TECHNICAL BULLETIN

[Issue No.] T20-0010

[Title] GX Configurator-SC Version2.01B (SW2D5C-QSCU-E)
Specification change in number of input variable entries
and relevant precautions

[Date of Issue] Aug, '03

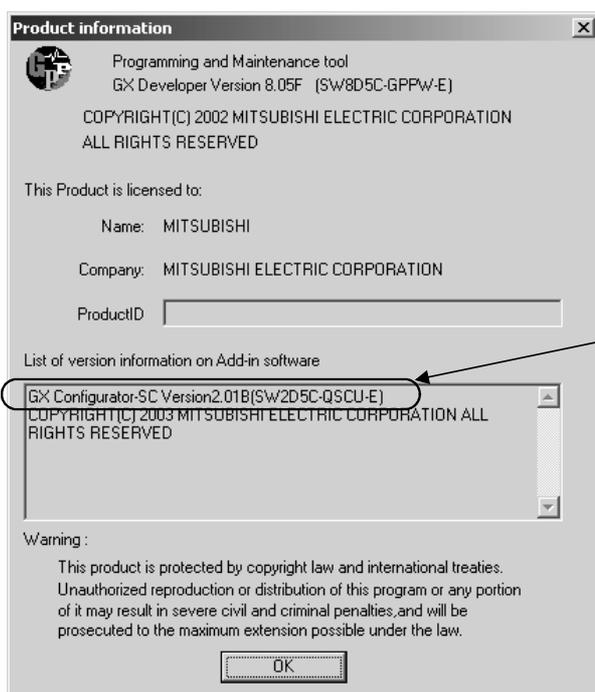
In the GX Configurator-SC Version2.01B (SW2D5C-QSCU-E), the maximum number of input variable entries for send packets has been changed as follows.

The maximum number of input variable entries available for send packets has been changed from 18 to 8.

If 9 or more input variables have been used for send packets, revise the send packet construction and change the number of entries to 8 or less.

- Merge consecutive input variables into one setting to reduce the number of input variables.
- Change some item setting from "Input variable" to "Fixed data" if possible.
